Work Order ID 130412

Item ID: D350-604-041 Accept ***N900040100*** Setup Start ***NS1***
 Revision ID: Stop ***NS2***
 Item Name: Rear Locker Extender
 Start Date: 3/10/2015 Start Qty: 1.00 ***1*** Cust Item ID:
 Required Date: 10/15/2015 Req'd Qty: 1.00 ***1*** Customer:
 Reference:

D2273 REAR LOCKER EXTENDER

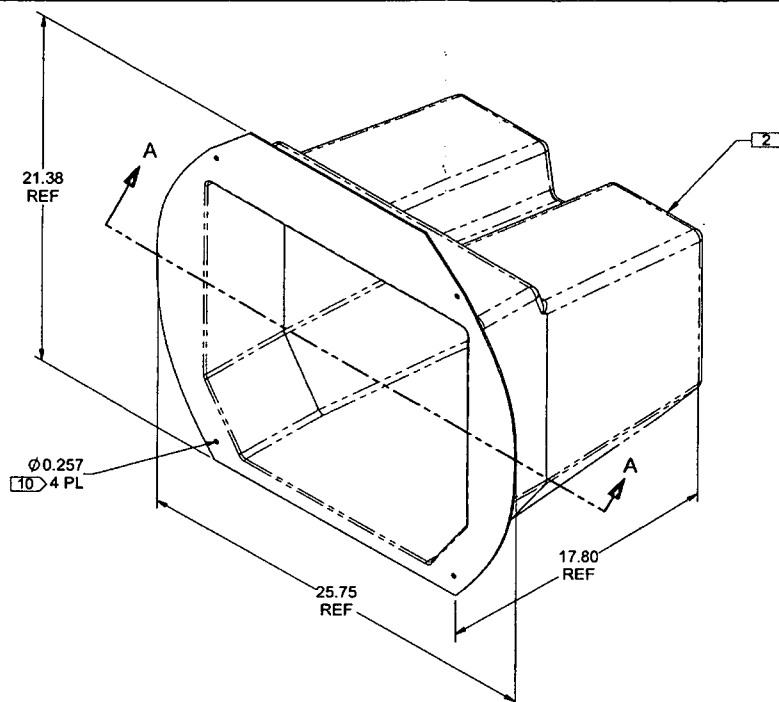
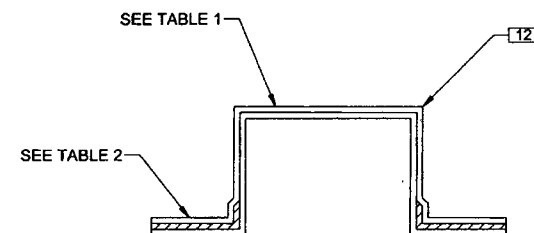
L	ADD PAINT OPTION (NCR 15-5408)	CP	15.10.19
K	LAYUP AND MAT'L PER FDC COMPOSITES PROCESS	CP	15.03.12
J	CHANGED GELCOAT TO 4314-001 DURA FR WHITE	ML	13.12.10
I	CHANGE GELCOAT TO POLYCOR 2330PAWK745	SFM	13.08.13
H	CHANGE MATERIAL & MANUFACTURING PROCESS	DC	13.03.15
G	ADD MANUFACTURING OPTION B, ZN B5-1	DC	12.08.08
F	PRIMER LE 3404-S/LE 1175-S WAS 1144-S, ZN A6-1	DC	12.02.27
E	CHANGED SURFACE FINISH FROM 944W005 GELCOAT TO 2330PAWK745 GELCOAT, ZN A7-1. UPDATED DWG TO CURRENT STANDARDS.	DC	12.02.02
D	REMOVE EPOCAST, ADD SURFACE FINISH	CP	02.04.01
C	CLARIFY MATERIAL, LAYUP, AND TOOLING	RF	02.01.30
B	RE-DRAWN	MM	06.05.27
REV.	DESCRIPTION	BY	DATE

- 1) MATERIAL: SEE TABLE 3
- 2) FINISH: SEE TABLES 1, 2, & 3
ACCEPTABLE TO COVER CRACKS IN GELCOAT BY APPLYING A LAYER OF
PPG 6941241A 2C ACRYCOTE WHITE PAINT OVER GELCOAT
- 3) TOLERANCES: PER DART QSI 018 UNLESS OTHERWISE NOTED
- 4) UNITS: INCHES UNLESS OTHERWISE NOTED
- 5) BREAK SHARP EDGES: 0.005 TO 0.010 MAX
- 6) IDENTIFICATION: IDENTIFY PER QSI 044 6.1
- 7) WEIGHT: 5.5- 7.5 lbs
- 8) LAMINATE PER DART QSI 006. LAMINATION SCHEDULE PER THIS DRAWING
- 9) LAYUP USING DT9871 MOLD. WET LAYUP WITH BAG/VACUUM
- 10) TRIM & DRILL PER DT9905. OPEN HOLES TO Ø0.257
- 11) CONSTRUCTION: SEE TABLES 1 & 2
- 12) MATTE TO HOLD DOWN CORNERS AS REQUIRED
